## **ZONING CHANGE REVIEW SHEET**

**CASE:** C814-2017-0001 – 425 W. Riverside PUD

**ADDRESS:** 425 W. Riverside Drive

**ZONING FROM:** CS-1-V-NP      **TO:** PUD-NP

EXHIBIT F - LAND USE PLAN-OPEN SPACE

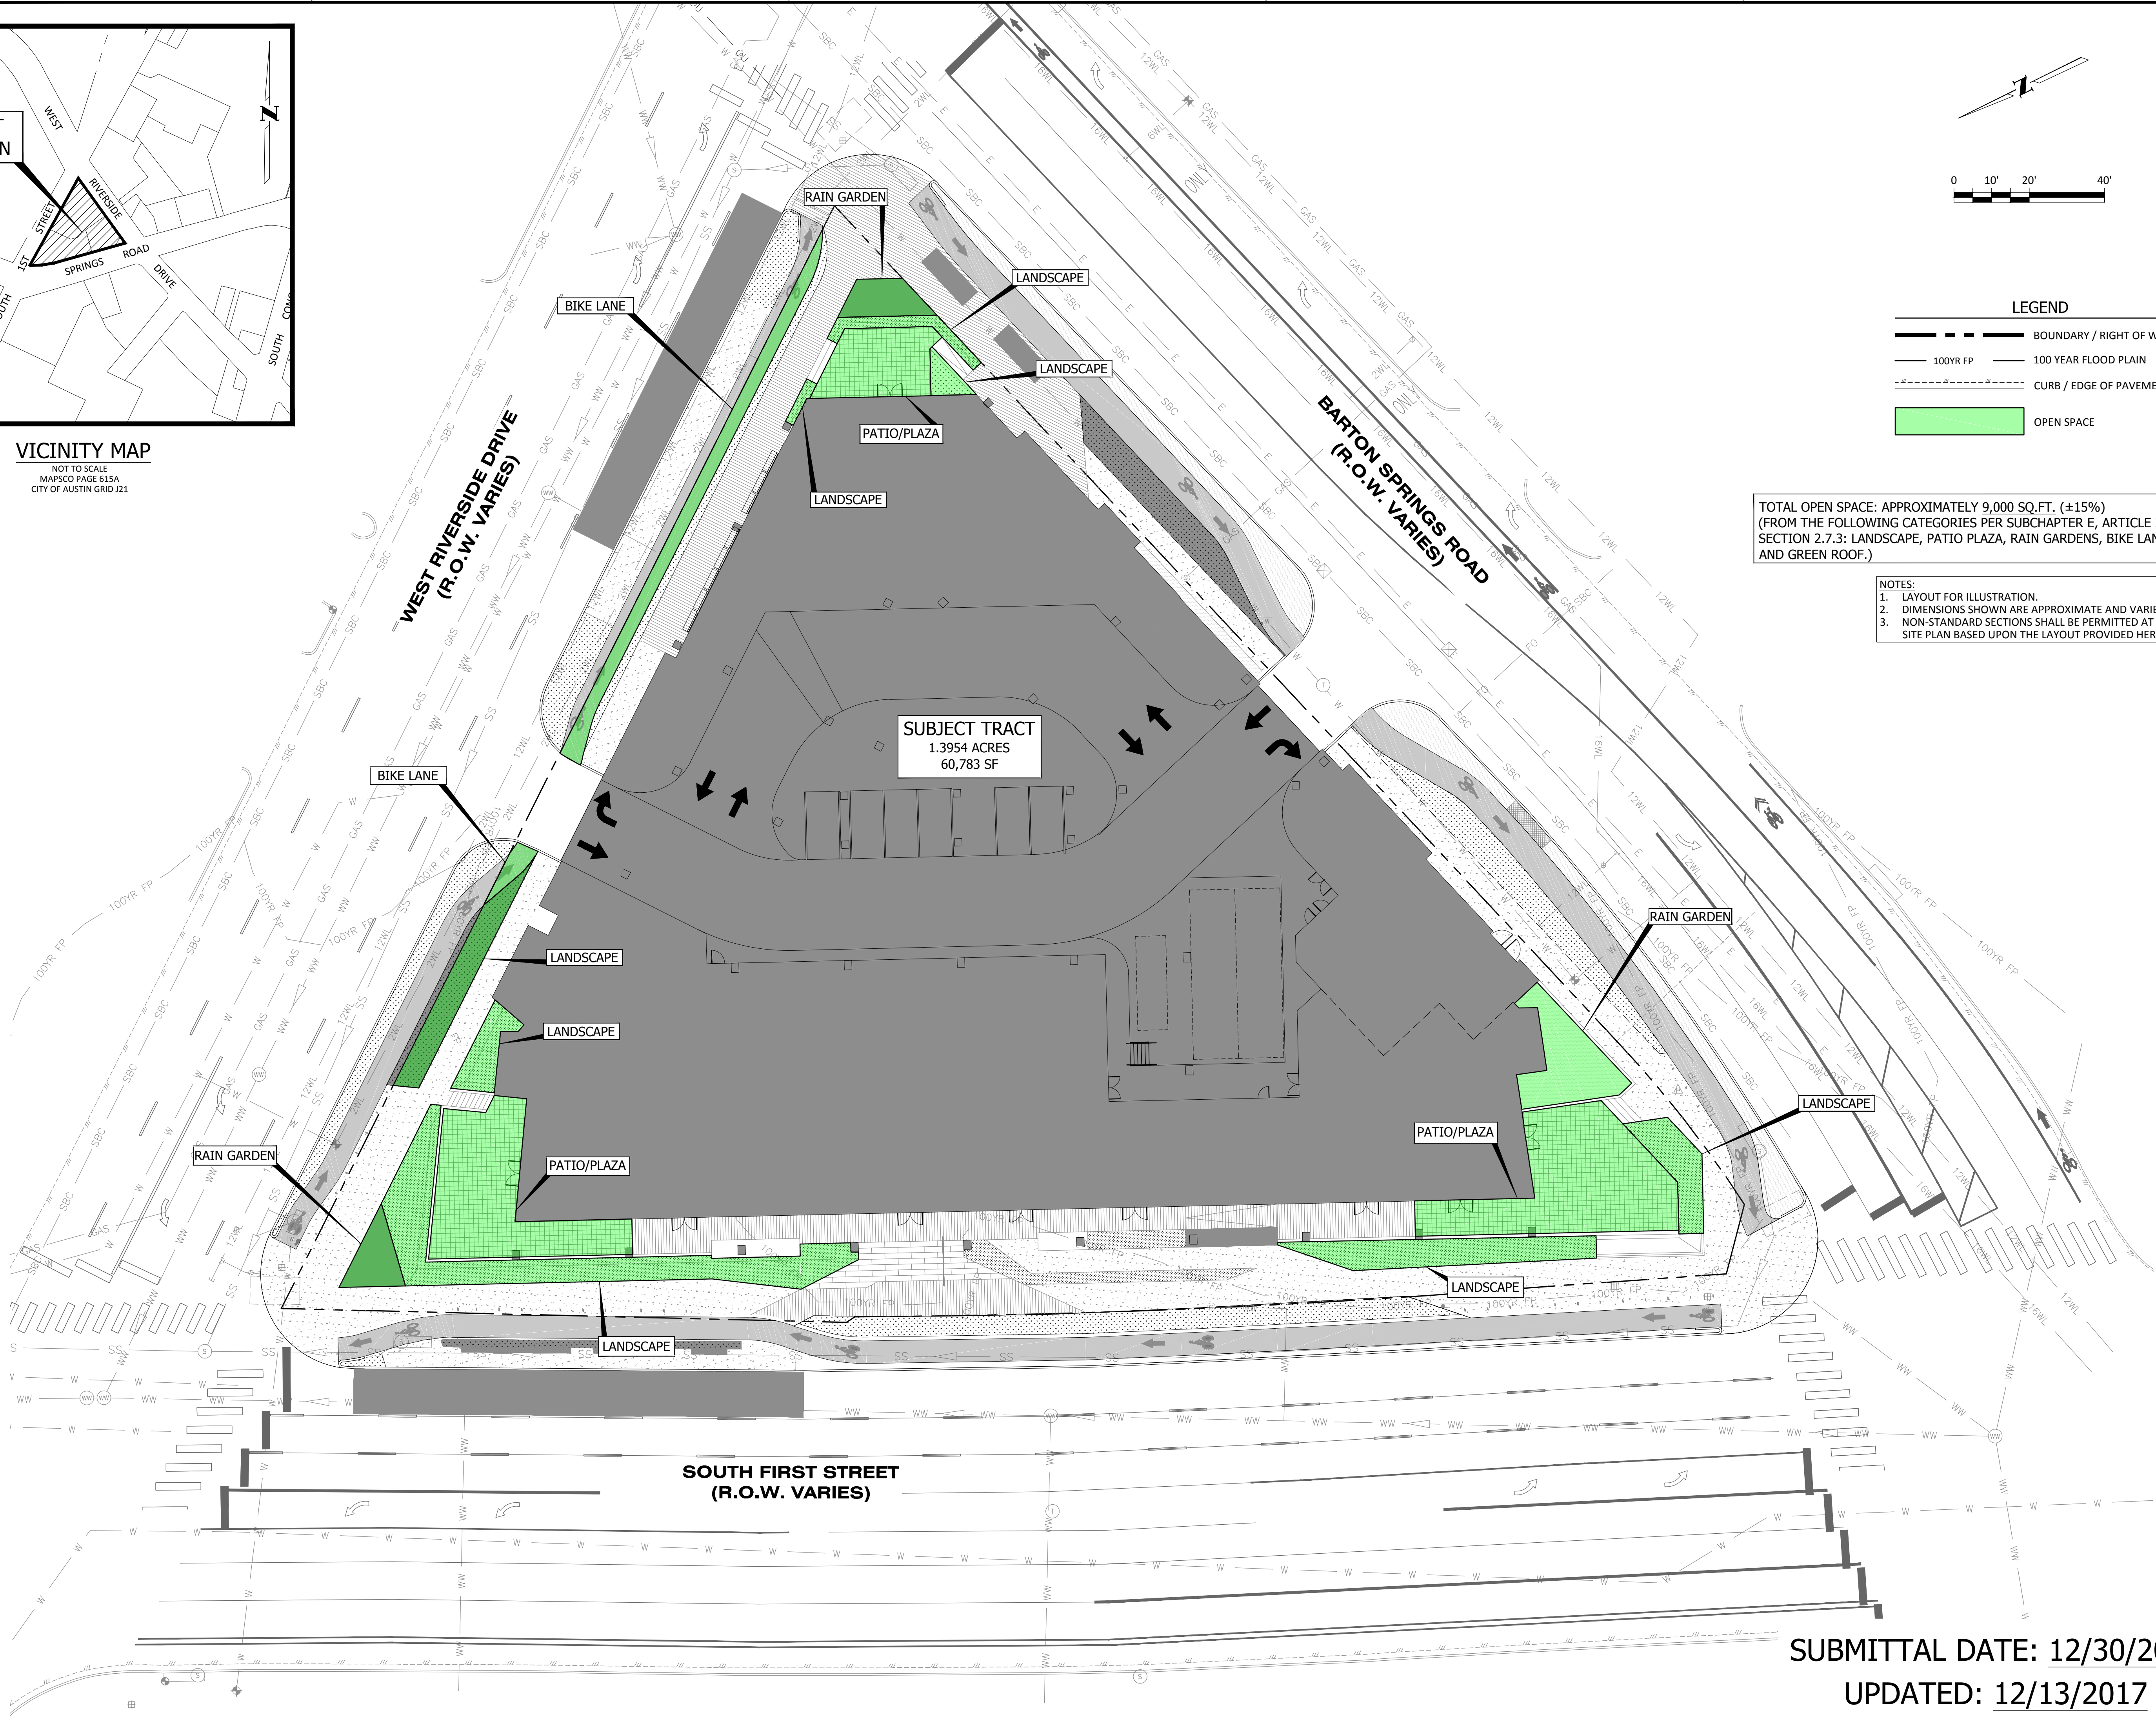
**U3: The proposed Open Spaces A, B, C, and D (green roof) are acceptable, as is the minimum commitment of 15% of the site. However, please prepare an open space exhibit that can be included with the PUD ordinance. (Something like the submitted exhibit can be used, but it currently says “for informational purposes only – Update 2”). This comment can be cleared informally.**

EXHIBIT - TREE PLANTING DETAILS

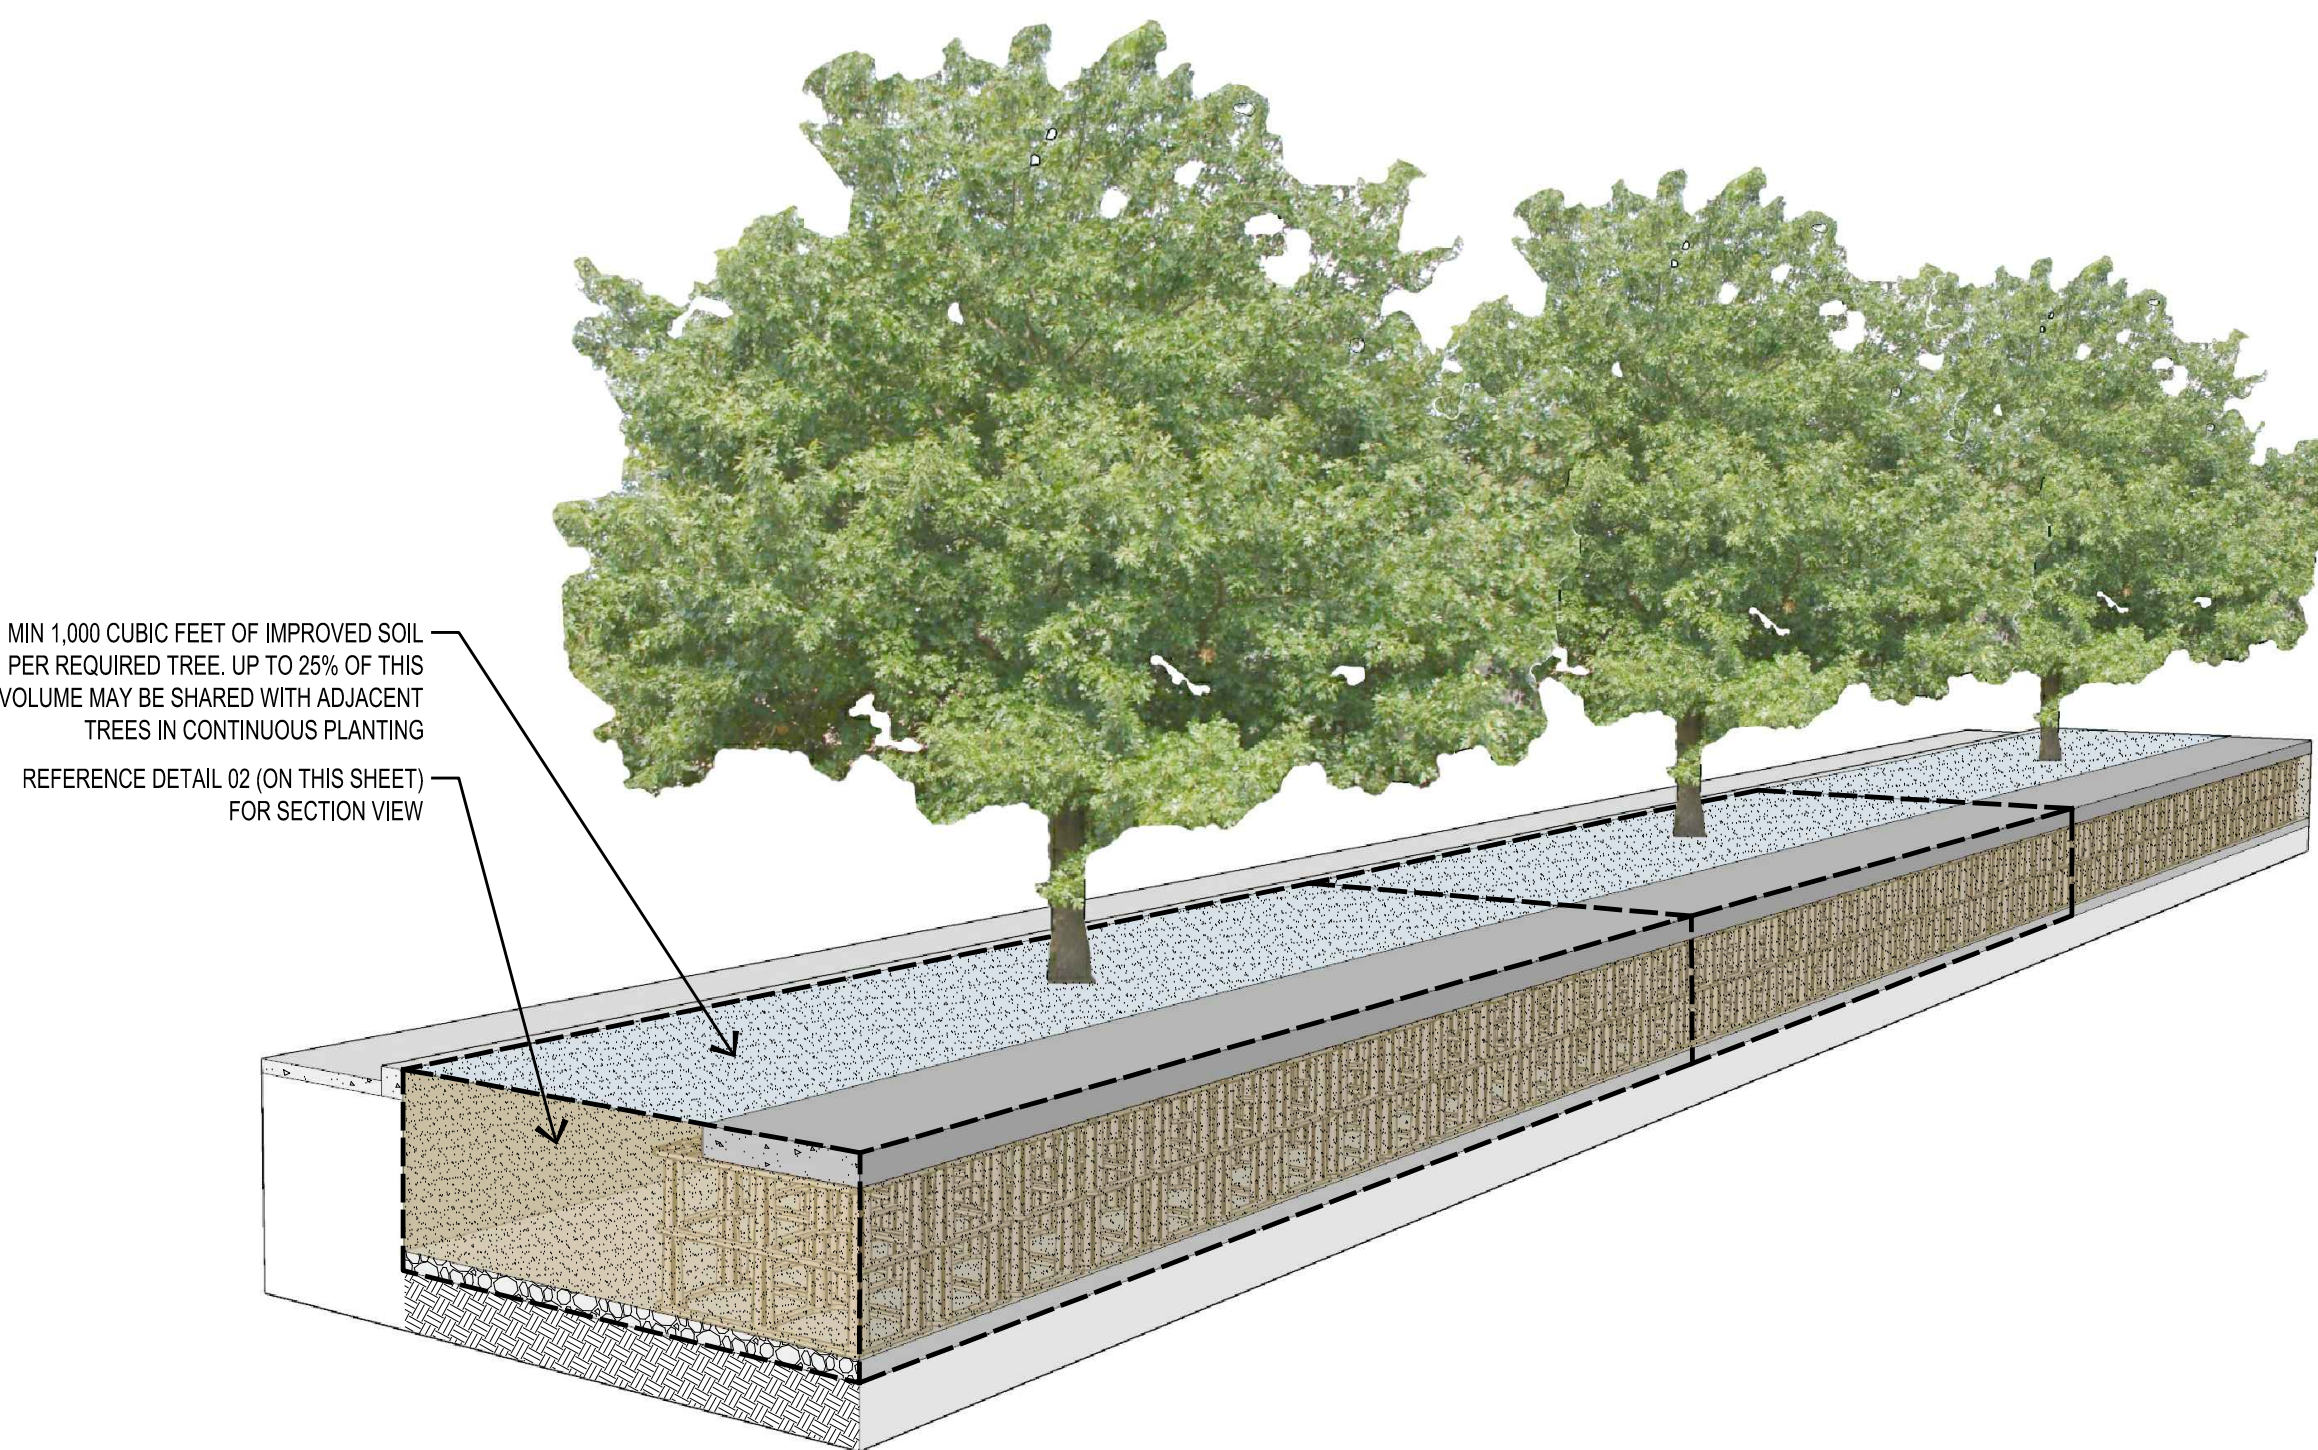
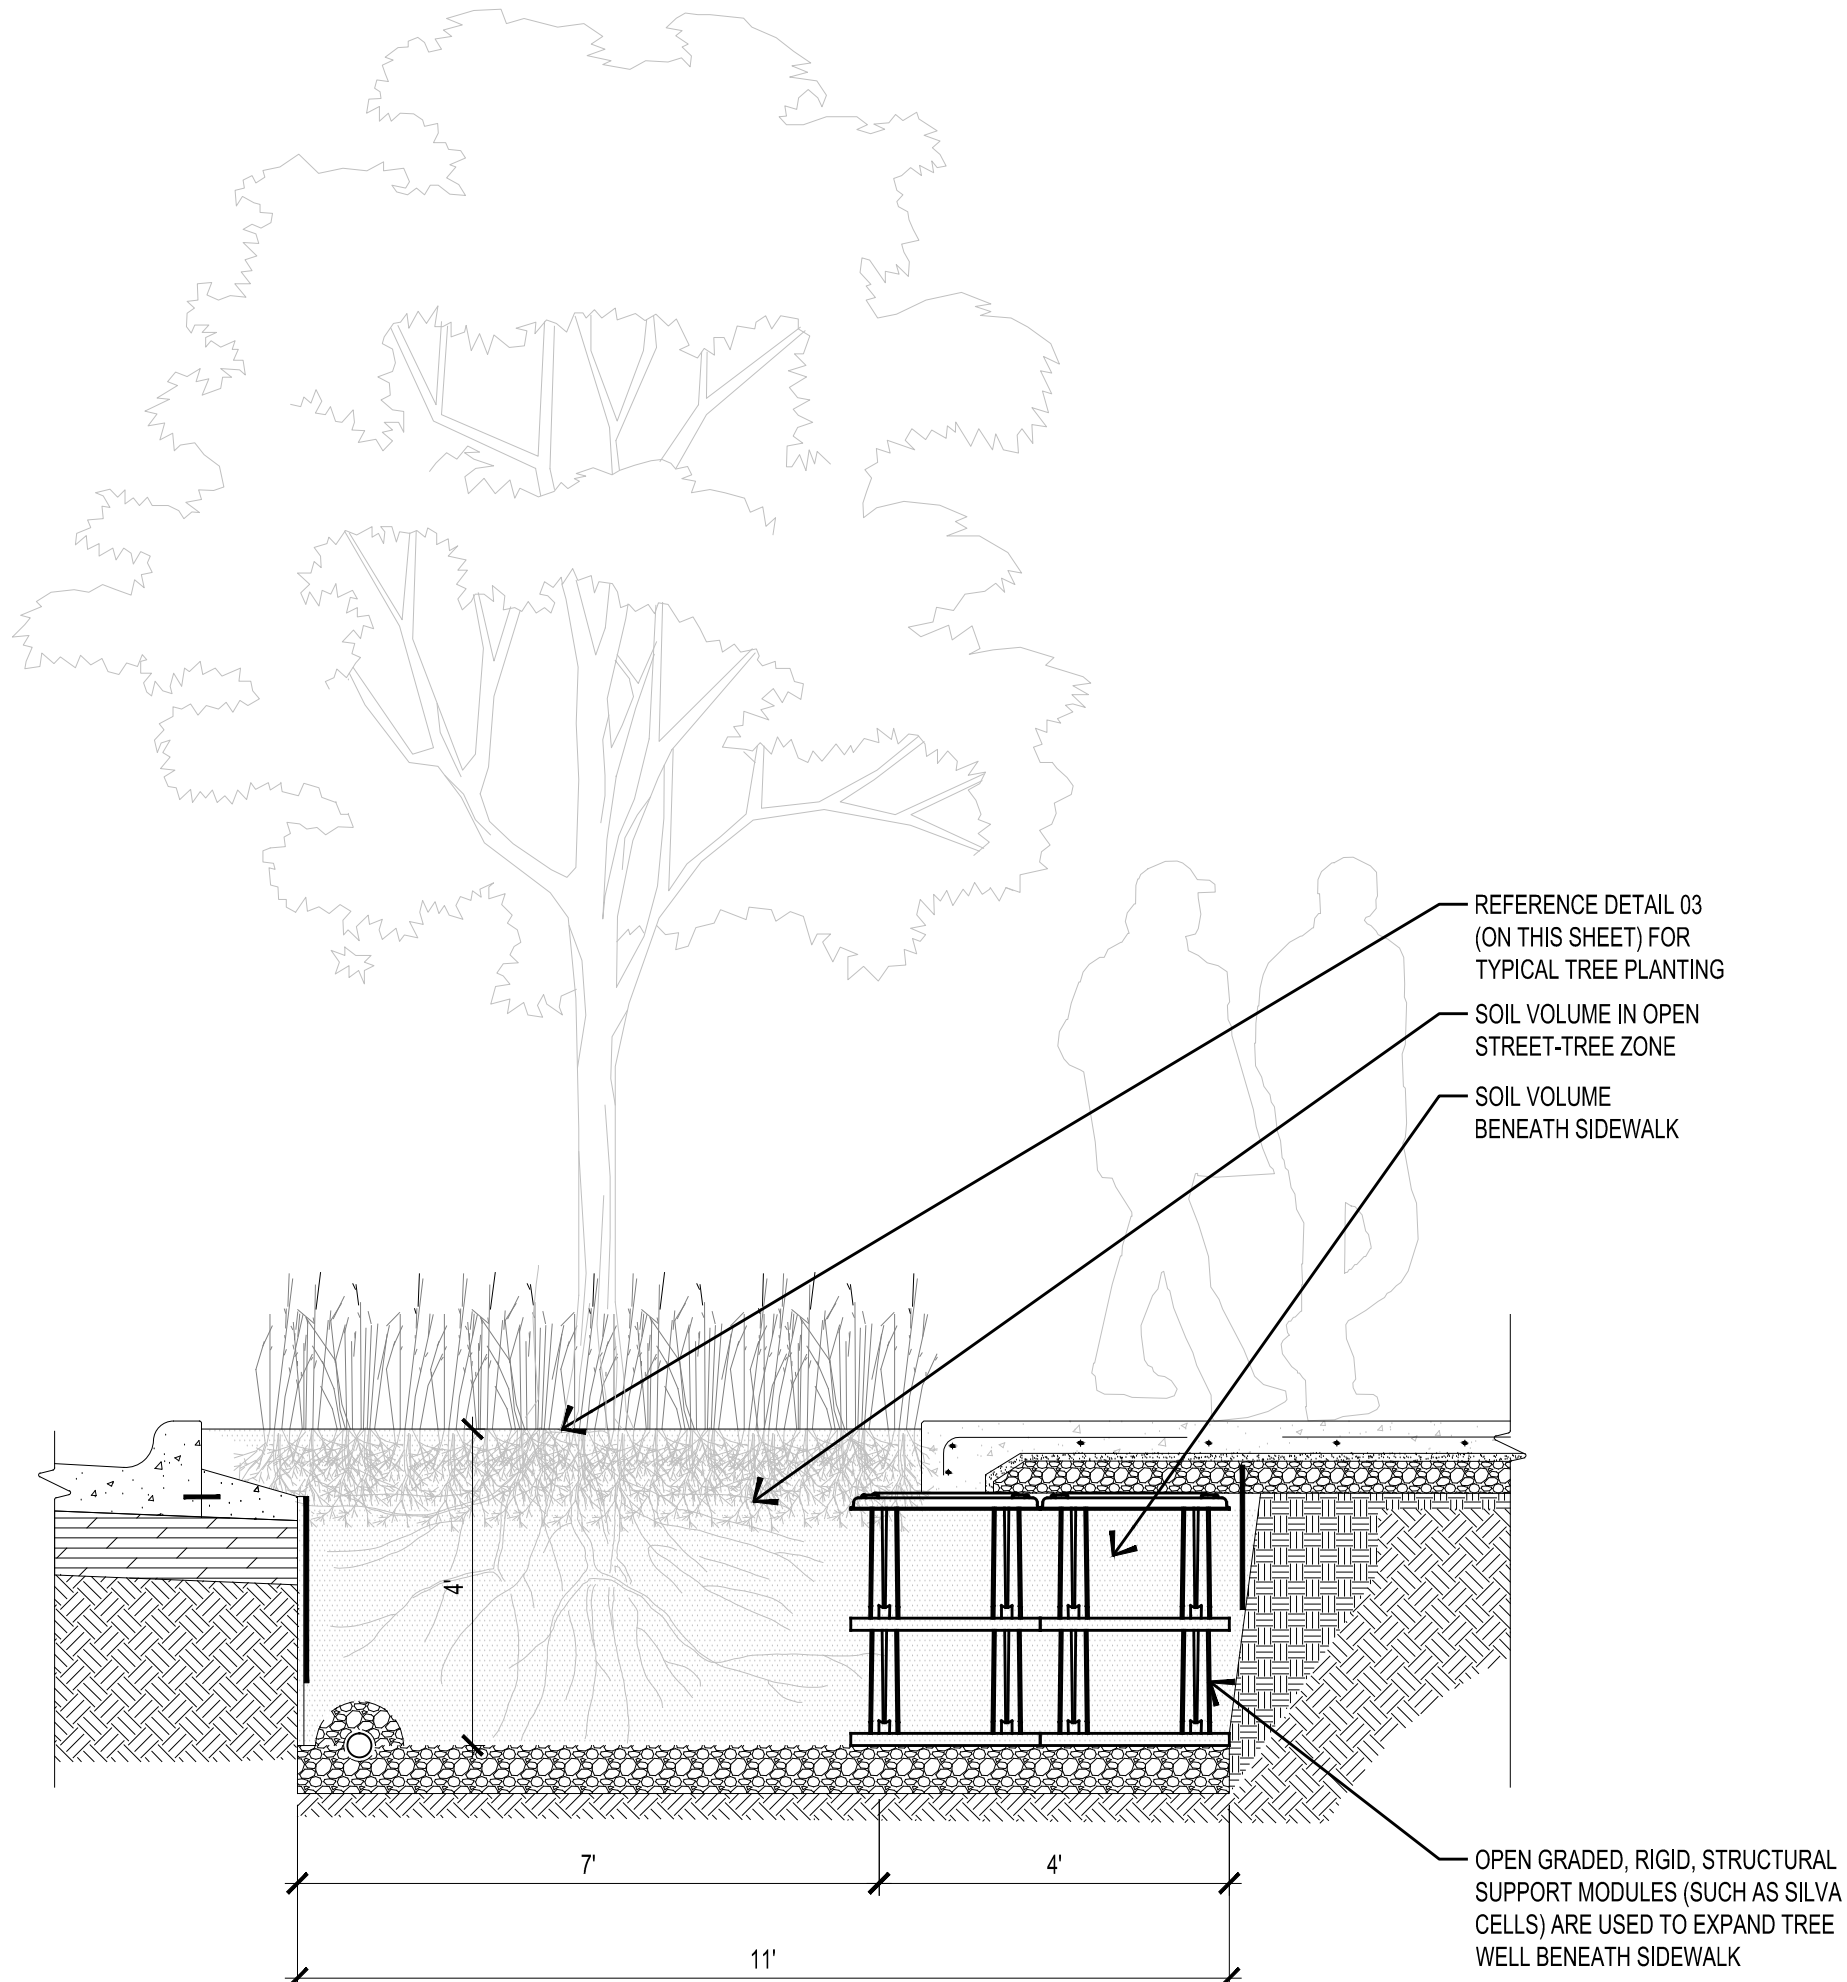
**UPDATE 1:** Please show how at the proposed spacing between street trees the PUD can achieve 1,500 Cu.Ft per tree. See HT 1 response. The proposed rain garden areas would not seem to be able to meet this area requirement if they were walled confined spaces. Please clarify if the planting zone is truly 8 feet or if it will really be 7.5 feet or less to account for the curb or any type of moisture barrier between the zone and back of curb. Comment pending.

**UPDATE 2:** Staff is still unclear how the overall inches to be planted number was derived as I only received one of the two exhibits mentioned in your response. Please provide at our next meeting for review. Soil volume will also be discussed and the commitments and exhibits needed for the final PUD document. Comment pending.

**UPDATE 3:** Thank you for the additional information and calculations. While the PUD proposed planting of a larger diameter street tree could be considered for some environmental superiority, it would normally be a proposal to plant more trees than what would be required that would carry more weight. The PUD proposes a starting overall total frontage a bit less than the current code scenario. It also proposes an additional loss of frontage to accommodate greater options for alternative transportation with two new bus stops. These additional losses in total only allow the PUD scenario to plant one additional tree than the current code option. In this case, it will be the guarantee to plant a shade tree of higher quality that will carry some environmental superiority. To this point, because a multiplier has been used in both calculations to estimate loss due to utility conflicts and not on the ground verification staff is still not able to support the overall tree planting estimates.

**Please also revise your soil commitments and notes to be consistent with the last update. These should include the larger 1540 CY soil volume required in locations other than ones with utility conflicts. In those cases where it is proven utility conflict then 1000 CY minimum is accepted with the use of soil cells. Comment pending.**

**UPDATE 3: Using the ANSI planting standards is acceptable but not superior, as these would be done anyway. Please explore additional standards for tree quality, to assure the best possible tree stock is available for the PUD. These could include presence of visible root flare a time of planting and no girdling roots. Comment pending.**
